DIVISION OF ENVIRONMENTAL PROTECTION

July 21, 2008

Re: **Tronox LLC (TRX)**  
**NDEP Facility ID #H-000539**  
Nevada Division of Environmental Protection (NDEP) Response to:  
*Phase B Source Area Investigation Work Plan Area III (Eastern LOUs). Tronox LLC*  
*Facility, Henderson, Nevada*  
Dated June 27, 2008

SAMPLE LOCATIONS FOR LOU #20, POND C-1 AND ASSOCIATED PIPING IN AREA III		
Phase B Area III Source Area Investigation		
Tronox Facility		
Henderson, Nevada		
SCALE:	DATE:	PROJECT NUMBER:
AS SHOWN	6/4/2008	04020-023-430

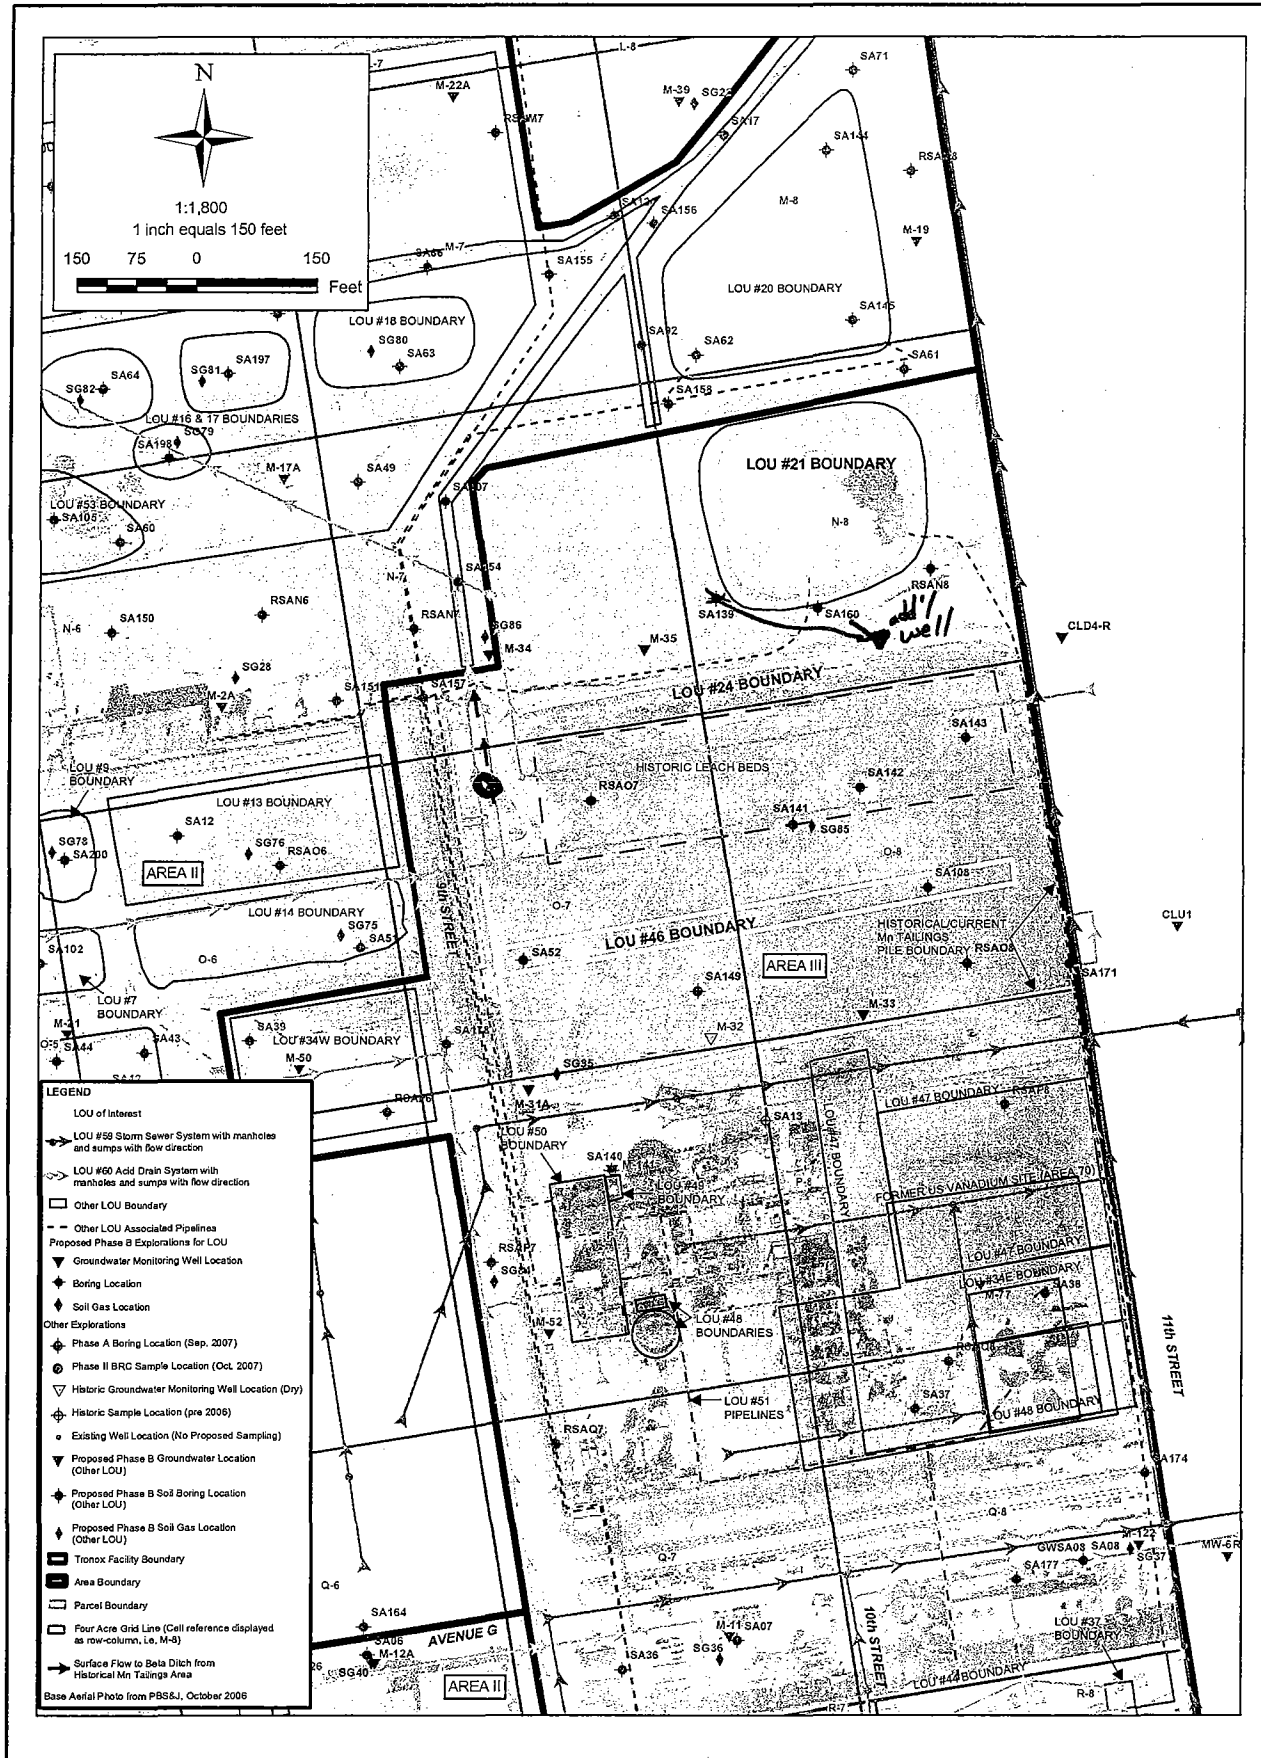
- i. RSAP7 should be moved north adjacent to LOU 59 just past where LOU 59 crosses LOU 60.

- ii. SA36 should be moved north adjacent to LOU 20 piping and over LOU 60.
- iii. Significant inconsistencies have been noted between Table A, the text of the area-specific CSM, and the main body of the report. For example, based upon the text, all judgmental samples should include TPH analysis. Table A does not show this, please note that this analysis should be added. Table A includes dioxin/furan analysis, however, this is not described in the text. No change to the table is necessary. SVOC analysis proposed on the Table is also not consistent with the text. SVOC analysis should be added to location SA36. These comments are compiled into the NDEP's comments listed above for Table 2, however, they are included herein as an example.

• move BSA P7 adjacent to LOU 59 and near intersection with LOU 60.  
 • move SA36 north to be over LOU 60.

SAMPLE LOCATIONS FOR LOU #24 AND #46 MN TAILINGS AREA AND OLD MAIN COOLING TOWER Phase B Area III Source Area Investigation Tronox Facility Henderson, Nevada		
SCALE:	DATE:	PROJECT NUMBER:
AS SHOWN	6/9/2008	04020-023-480

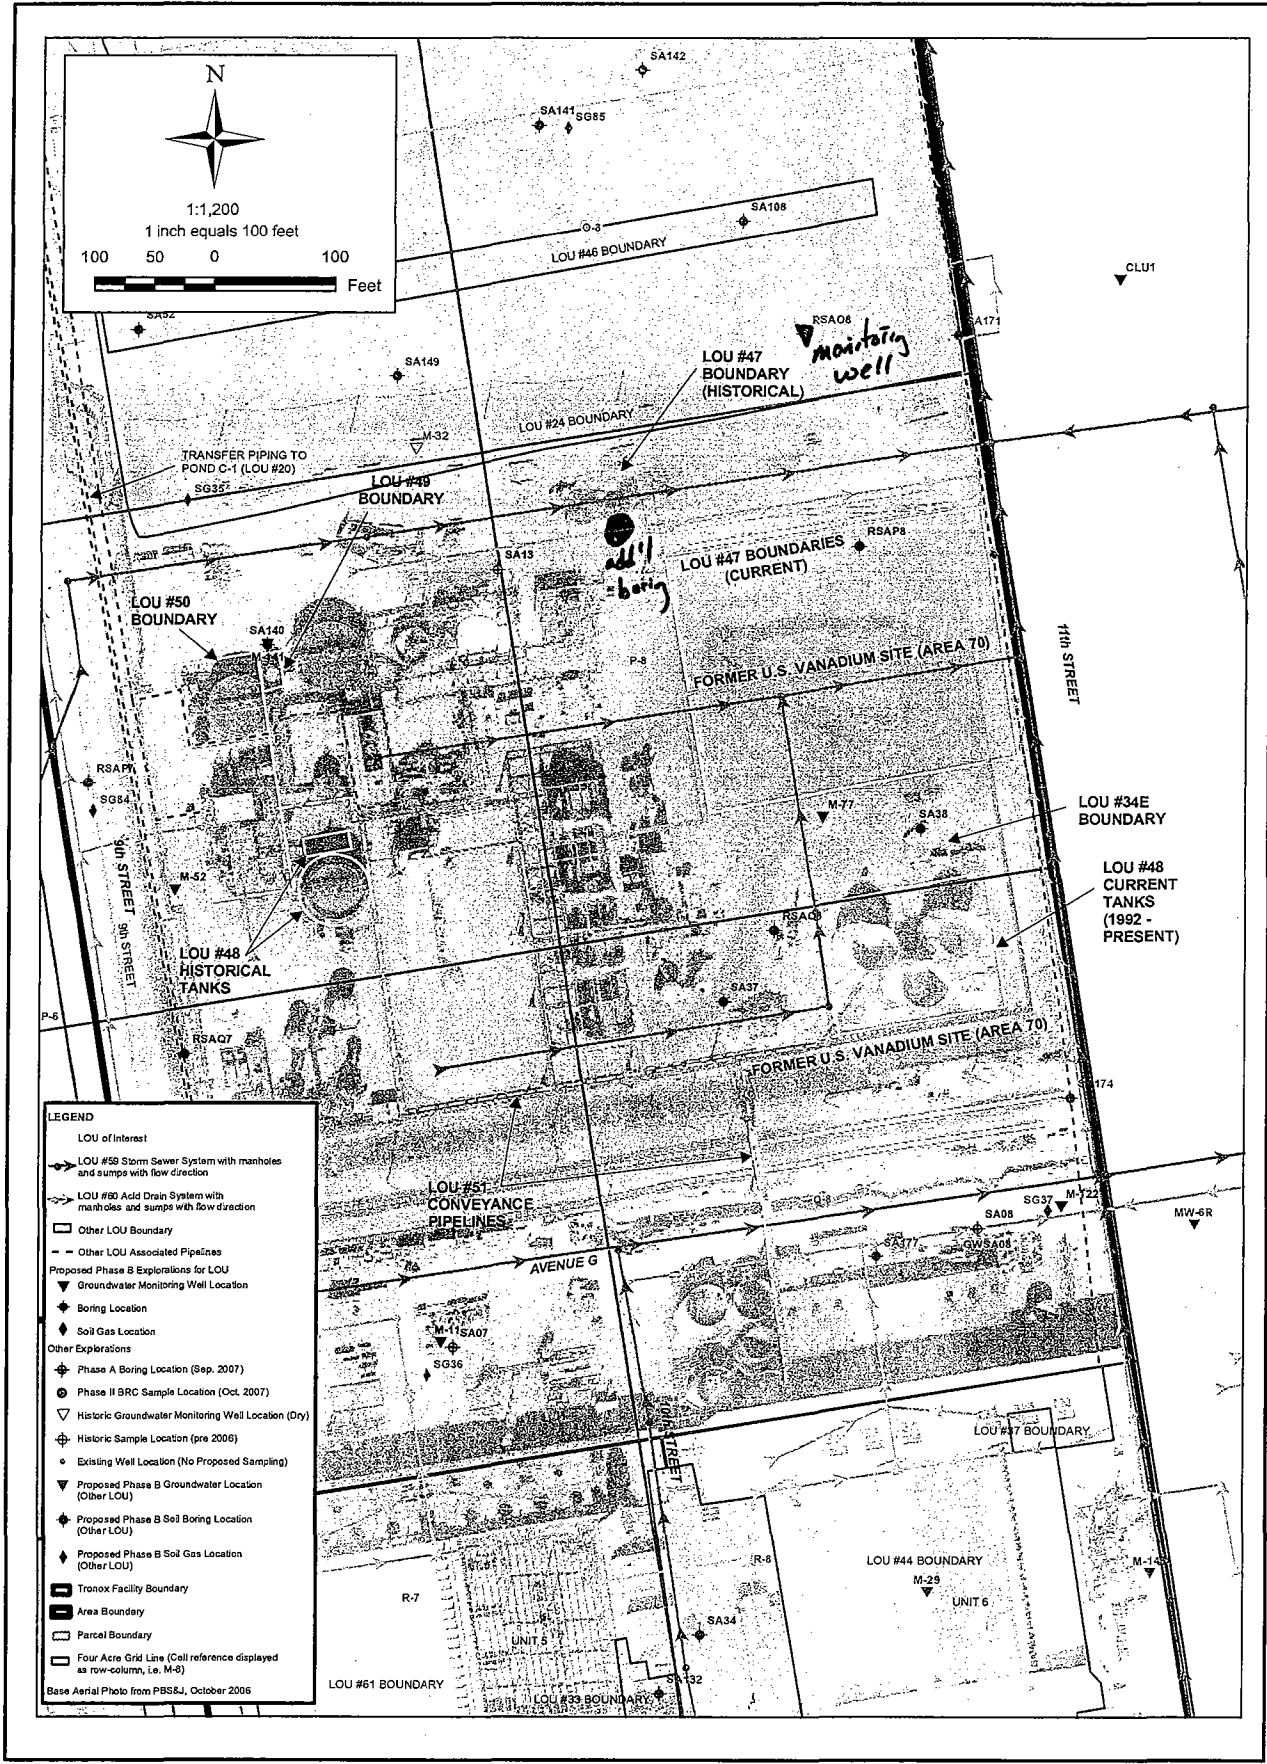
- vi. SA139 should be moved to a point just north of the Mn tailings pile approximately halfway between wells M-35 and CLD4-R. Additionally, a groundwater monitoring well should be installed at this location.

- vii. An additional boring should be located within the surface flow area indicated on Figure A of the LOU.
- b. LOU 34E, 47, 48, 49, 50, 51, and Area 70 (Operational Manganese Leach Plant and Former US Vanadium Site)

additional boring located in surface flow from MN TAILINGS Area  
 near SA139 to just north of LOU 24 & convert to monitoring well.

**SAMPLE LOCATIONS FOR LOUs #34E, #47, #48, #49, #50, #51 AND AREA 70 (FORMER U.S. VANADIUM SITE)**

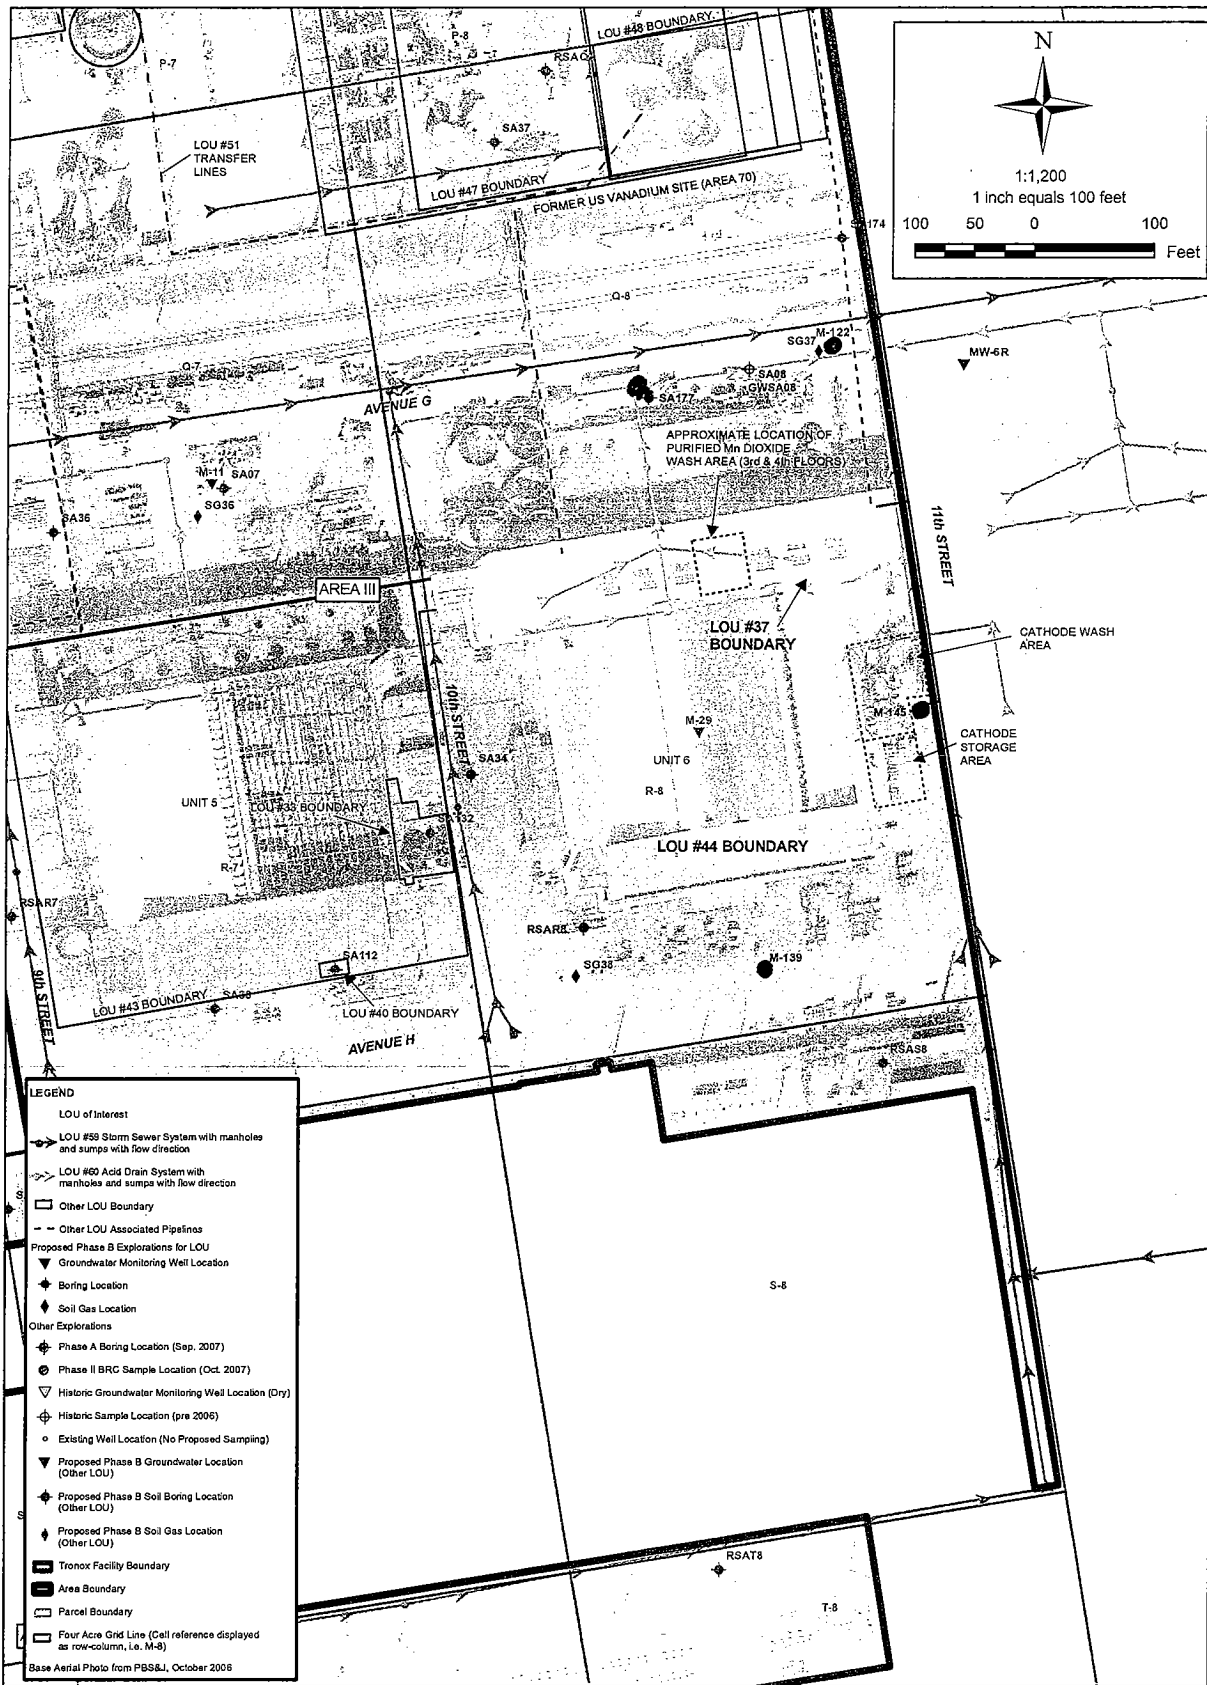
- iii. RSAO8 should be converted to an additional groundwater monitoring well.
  - iv. An additional boring should be located in the northern portion of LOU 47 (Historical) over LOU 60.

Additional boring on LOU 60 in northern portion of historical cavity.  
 Convert RSA08 to monitoring well.

SAMPLE LOCATIONS FOR LOUs #44 & #37 UNIT 6 BASEMENT & FORMER SATELLITE ACCUMULATION POINT - UNIT 6 MAINTENANCE SHOP Phase B Area III Source Area Investigation Tronox Facility, Henderson, Nevada		
SCALE:	DATE:	PROJECT NUMBER:
AS SHOWN	6/4/2008	04020-023-430

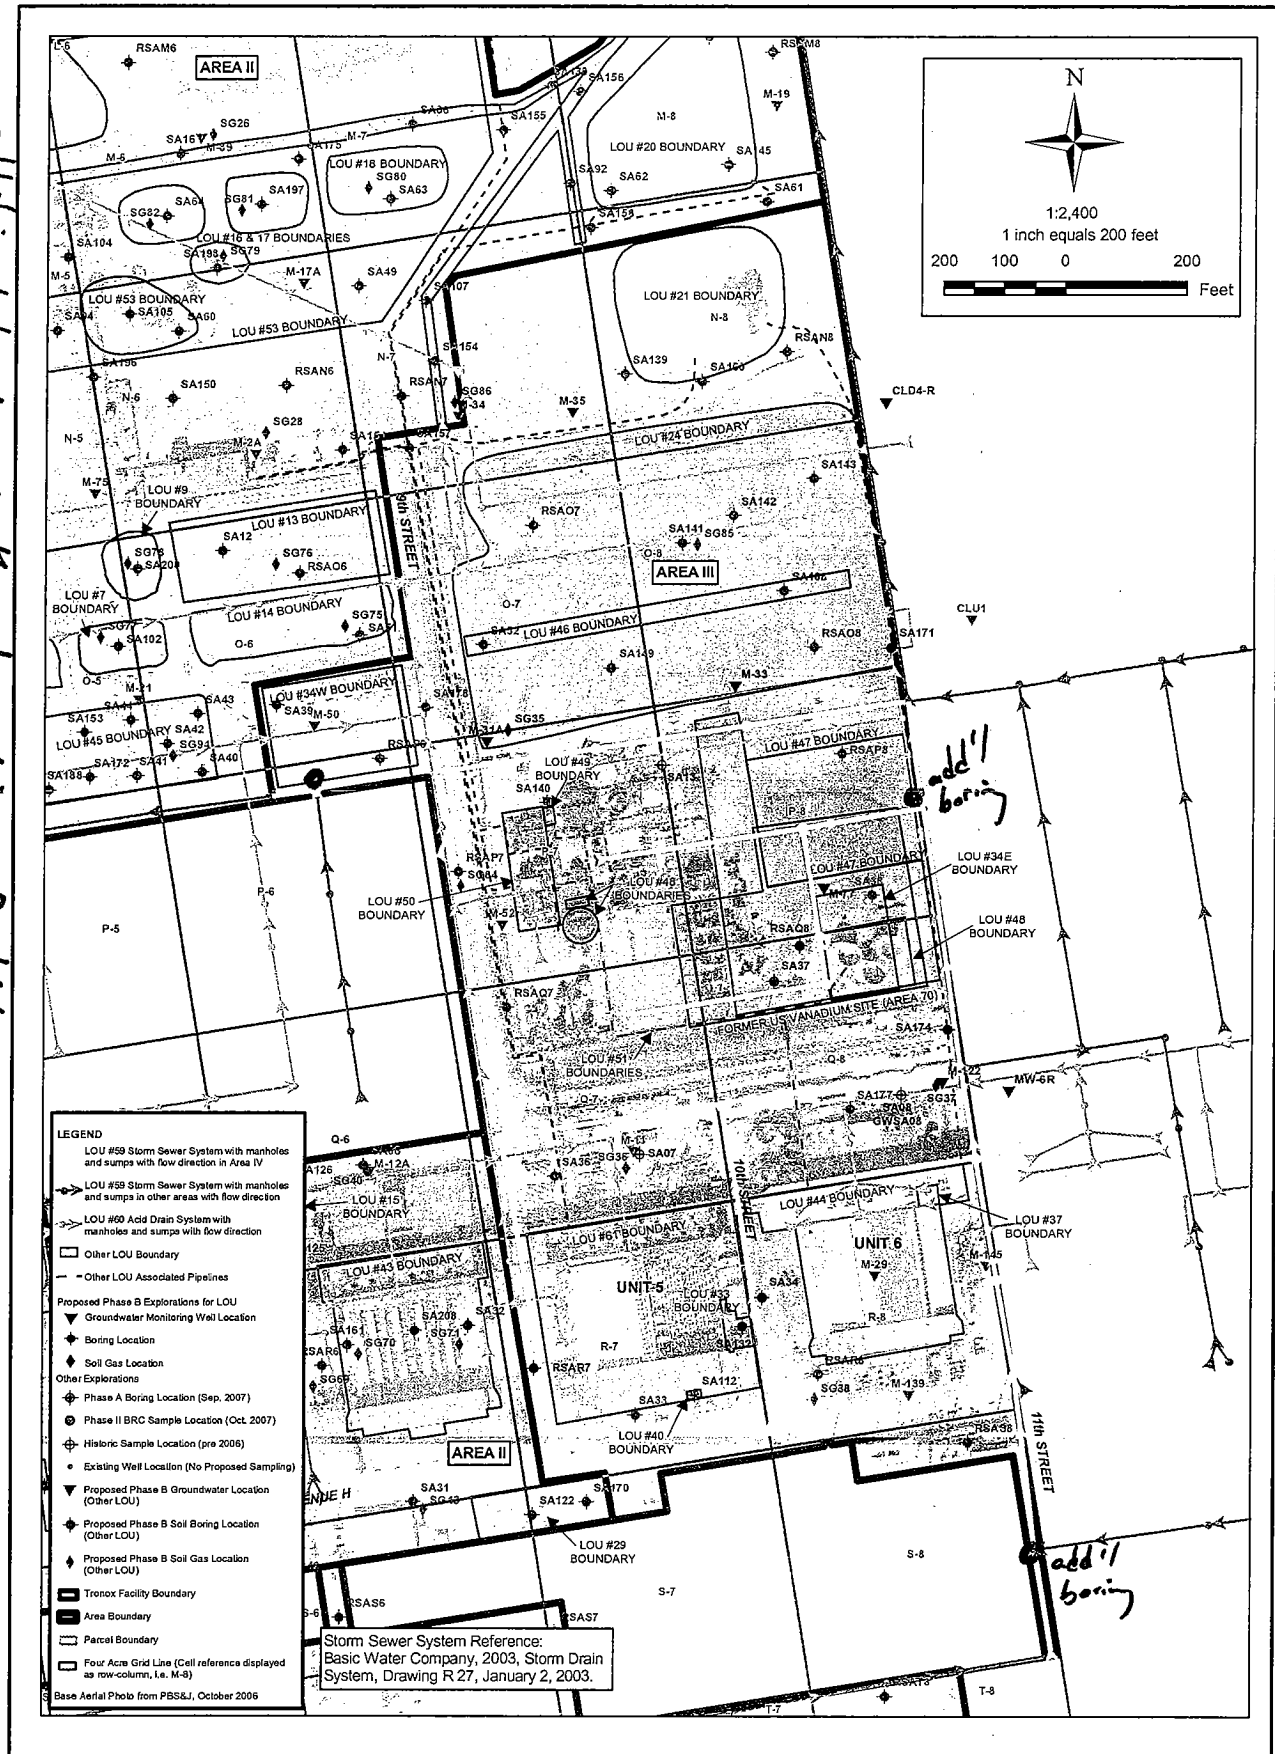
- iv. M-122, M-145, and M-139: samples should be collected during boring advancement.
- d. LOU 59 (Storm Drain System Segment), the NDEP has the following comments (please see the corresponding attached figure as necessary):

SA177 move to intersection/junction LOU 60.  
 Add borings (collect samples) for M-122, M-145 & M-139
